Amendments to the Drawings:

REMARKS

The preceding amendments and following remarks are submitted in response to the non-final Office Action mailed on November 10, 2008. With this Amendment, claims 1-5, 11-13, and 16-17 have been amended, and claims 6-10 and 14-15 have been cancelled. Claims 1-5, 11-13, and 16-19 are thus currently pending in the application. Reconsideration of all pending claims and allowance of the application in view of the present response is respectfully requested.

(Figure 2 of Application)

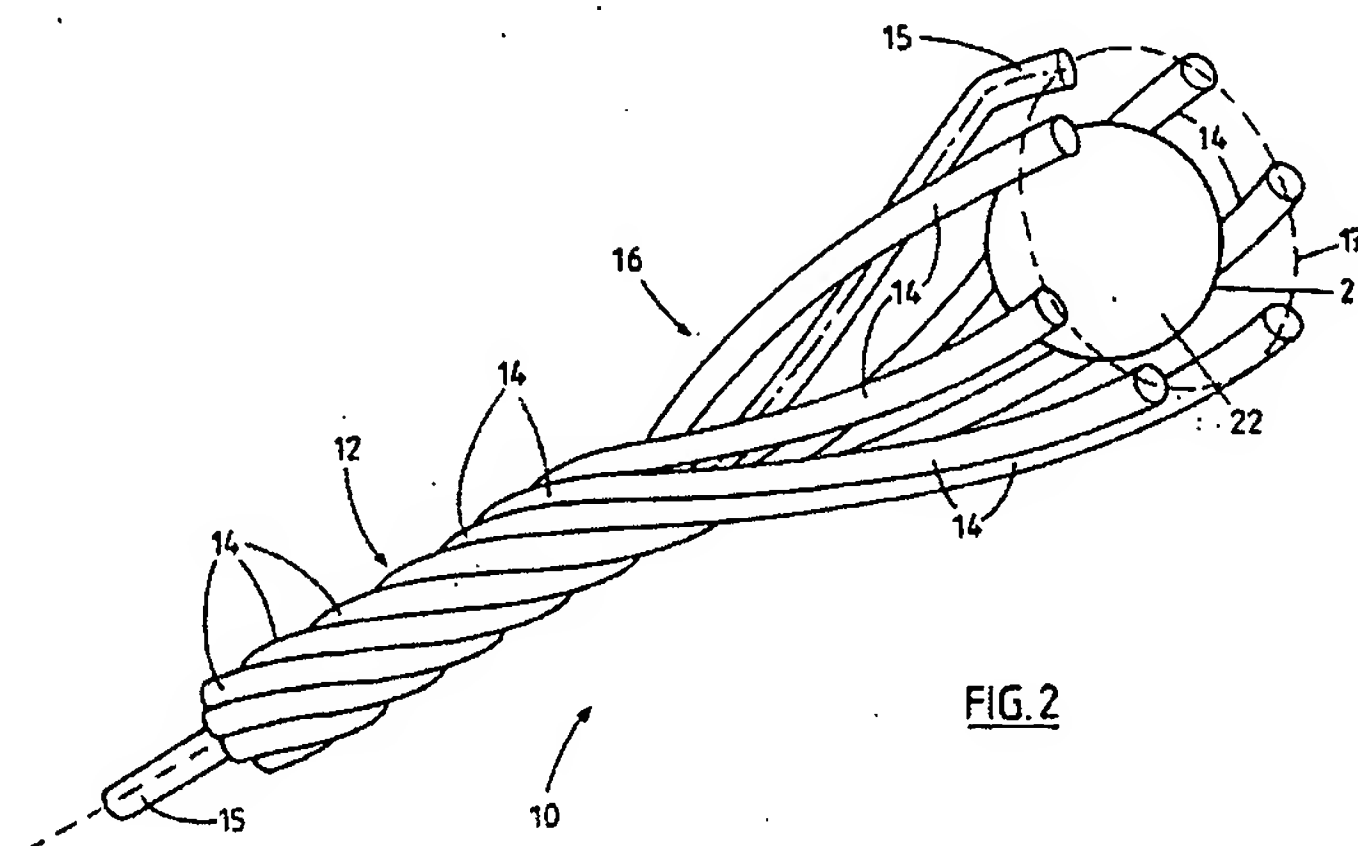
The attached replacement sheets include changes to Figures 1 and 2, and replace the original drawing sheets. In Figures 1 and 2, reference arrow "18" designating the cavity located in the bulbous portion (16) of the cable bolt (10) has been added.

With this amendment, Applicant has amended both Figures 1 and 2 to add reference arrow "18," which designates the "cavity" located in the bulbous portion (16) of the cable bolt (10). Support for this amendment can be found, for example, on pages 3-4 of the PCT specification (WO 2005/012691). No new matter has been added as a result of this amendment.

Specifically, independent claims 1, 11, 12 have each been amended to now recite “a plurality of rigid elements each including an outermost surface,” and that “all strands in each bulbous portion extend at least in part around the outermost surface of a rigid element contained in the bulbous portion.” Independent claim 16 has also been amended to now recite “a plurality of rigid elements each including an outermost surface,” and that “all the strands in the pre-formed bulbous portion extend at least in part around the outermost surface of a rigid element contained in the bulbous portion.” Method claims 13 and 17 have also been amended to now require “wherein all the strands in the (each) bulbous portion extend at least in part around the outermost surface of a rigid element contained in the bulbous portion.” Support for these amendments can be found, for example, on page 3, lines 19-21 and in Figure 2 of the present application (reproduced below), which shows all of the outer strands (14) and the center strand (15) extending at least in part around the outermost surface (22) of a rigid element (20) contained in the bulbous portion (16).
